ADDENDUM No. 1

REQUEST FOR QUOTATIONS No.: 1220-040-2024-085
TITLE: Fire Hall #1 and #2 Dorm Renovations
ADDENDUM ISSUE DATE: November 29, 2024
DATE: PREFER TO RECEIVE SUBMISSION ON OR BEFORE DECEMBER 12, 2024

FIRE HALL 2 – STRUCTURAL REVIEW

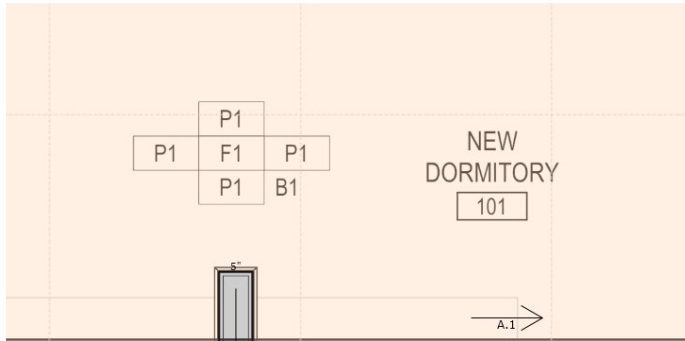
Contractor to retain a structural engineer registered in the province of British Columbia to review the weights and location of the new condensing unit and provide signed and sealed documents complete with letters and assurance.
